E/ECE/324 }
E/ECE/TRANS/505 } Add.4/Rev.3/Amend.1

Addendum 4: Regulation No. 5

Revision 3 - Amendment 1

UNIFORM PROVISIONS FOR THE APPROVAL OF MOTOR VEHICLE "SEALED BEAM" HEADLAMPS (SB) EMITTING A EUROPEAN ASYMMETRICAL PASSING BEAM OR A DRIVING BEAM OR BOTH

Figure 1

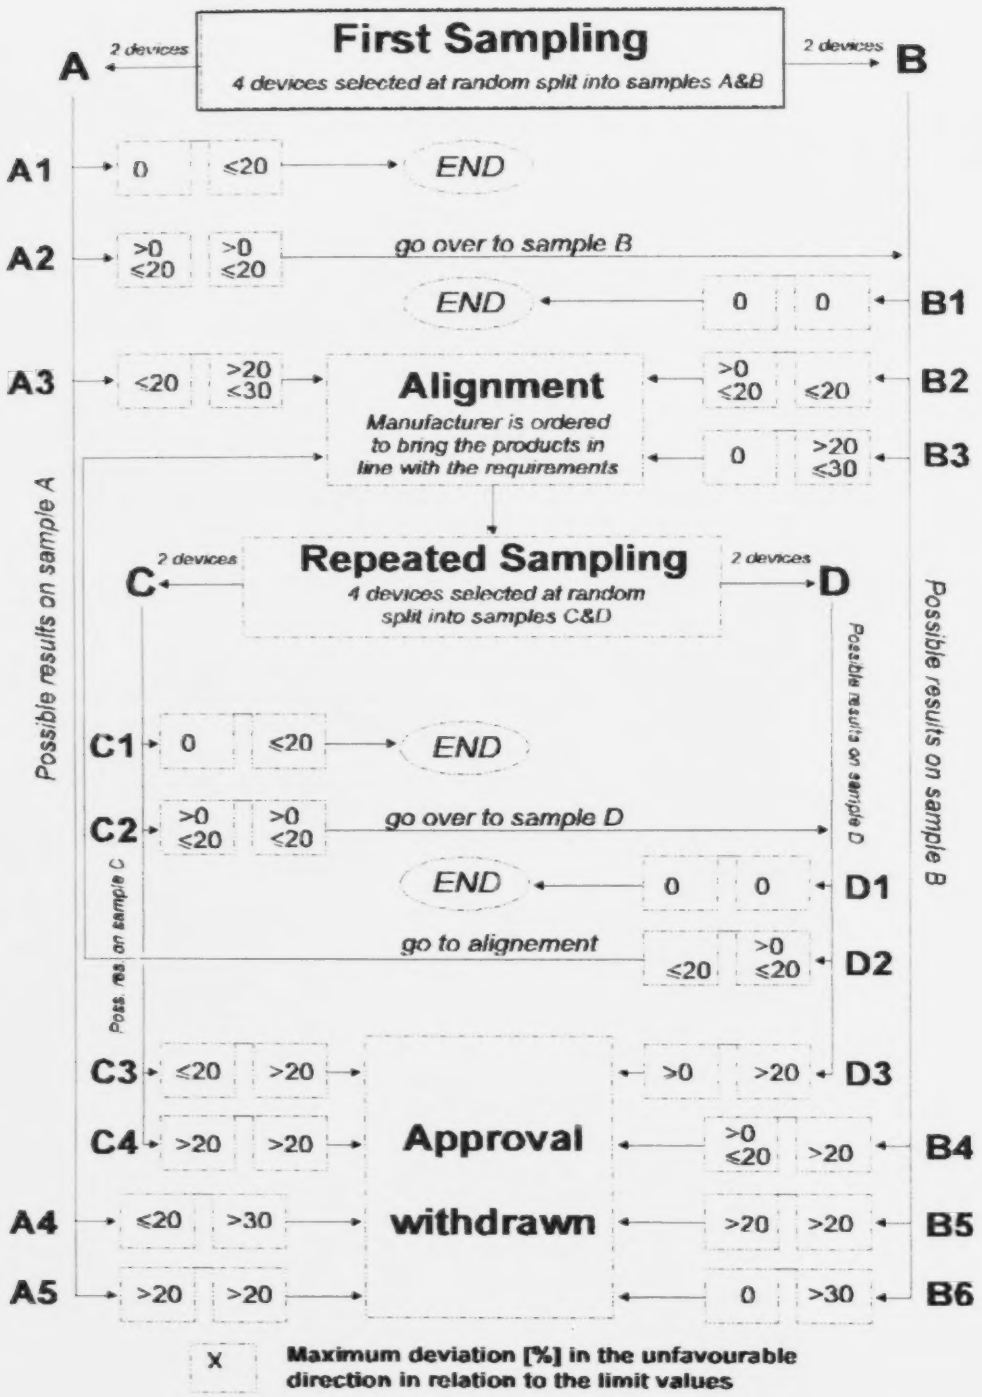
Add a new Annex 7, to read:

In the first sampling four headlamps are selected at random. The first sample of two is marked A, the second sample of two is marked B.

2.1.1. Following the sampling procedure shown in Figure 1 of this annex the conformity of mass-produced headlamps shall not be contested if the deviation of the measured values of the headlamps in the unfavourable directions are:

2.2.1. Following the sampling procedure shown in Figure 1 of this annex the conformity of mass-produced headlamps shall be contested and the manufacturer requested to make his production meet the requirements (alignment) if the deviations of the measured values of the headlamps are:

Conformity shall be contested and paragraph 10 applied if, following the sampling procedure in Figure 1 of this annex, the deviations of the measured values of the headlamps are:

In the cases of A3, B2, B3 a repeated sampling, third sample C of two headlamps and fourth sample D of two headlamps, selected from stock manufactured after alignment, is necessary within two months time after the notification.

3.1.1. Following the sampling procedure shown in Figure 1 of this annex the conformity of mass-produced headlamps shall not be contested if the deviations of the measured values of the headlamps are:

3.2.1. Following the sampling procedure shown in Figure 1 of this annex the conformity of mass-produced headlamps shall be contested and the manufacturer requested to make his production meet the requirements (alignment) if the deviations of the measured values of the headlamps are:

Conformity shall be contested and paragraph 13 applied if, following the sampling procedure in Figure 1 of this annex, the deviations of the measured values of the headlamps are:
